UNITED STATES PATENT AND TRADEMARK OFFICE

10/701,181

Office Action Summary	Application No. 10/701,181	Applicant(s) PARKER ET AL.	
	Examiner Sung H. Pak	Art Unit 2874

DETAILED ACTION

Fig. 14

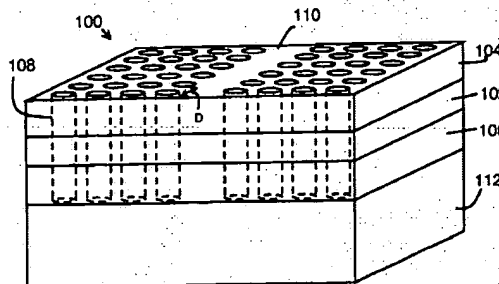
Cotteverte discloses an optical device with all the limitations set forth in the claims, including: a core layer having a first refractive index n_{core} ('102' Fig. 14); an array of sub-regions within the core having a second refractive index n_{rods} ('108' Fig. 14); the array of sub-regions giving rise to a photonic band structure experienced by an optical mode traveling through the waveguide structure (column 1 lines 18-33); and a cladding layer adjacent to the core layer having a refractive index n_{cladding} ('104' Fig. 14); wherein: $n_{\text{core}} > n_{\text{rods}} \geq n_{\text{cladding}}$ and $n_{\text{core}} - n_{\text{rods}} > 0.1$ (column 8 lines 1-8, column 8 lines 29-37, column 8 lines 41-44, column 8 lines 55-56: one example in which the condition $n_{\text{core}} > n_{\text{rods}} \geq n_{\text{cladding}}$ and $n_{\text{core}} - n_{\text{rods}} > 0.1$ is satisfied is when sub-region is filled with air (refractive index of 1), and both cladding and buffer layers are air, as disclosed in column 8 lines 55-56); wherein the array of sub-regions gives rise to a photonic bandgap (column 1 lines 18-33); wherein the waveguide structure is a planar waveguide structure (Fig. 14); further including a buffer layer ('106' Fig. 14); having a refractive index n_{buffer} , wherein the core core layer is positioned between the buffer layer and the cladding layer wherein $n_{\text{core}} > n_{\text{rods}} \geq n_{\text{buffer}}$ (column 8 lines 1-8, column 8 lines 29-37, column 8 lines 41-44; column 8 lines 55-56); wherein the core layer is formed from doped silica (column 8 lines 31-32); wherein the core layer may also be silicon, which has refractive index between 1.4 and 4 (column 8 lines 31-32: silicon *inherently* has refractive index values around 3.5. see "Refractive index of Silicon" by Primak); wherein the sub-regions extend through the cladding layer (Fig. 14); wherein the sub-regions extend fully into the buffer layer (Fig. 14); wherein the core layer includes a lateral waveguiding region having no sub-regions ('110' Fig. 14); wherein the waveguiding region includes a waveguide bend (Fig. 18).

refractive index greater than the cladding layer, but has equal refractive index as the sub-region in the core layer (Fig. 14 of Cotteverte).
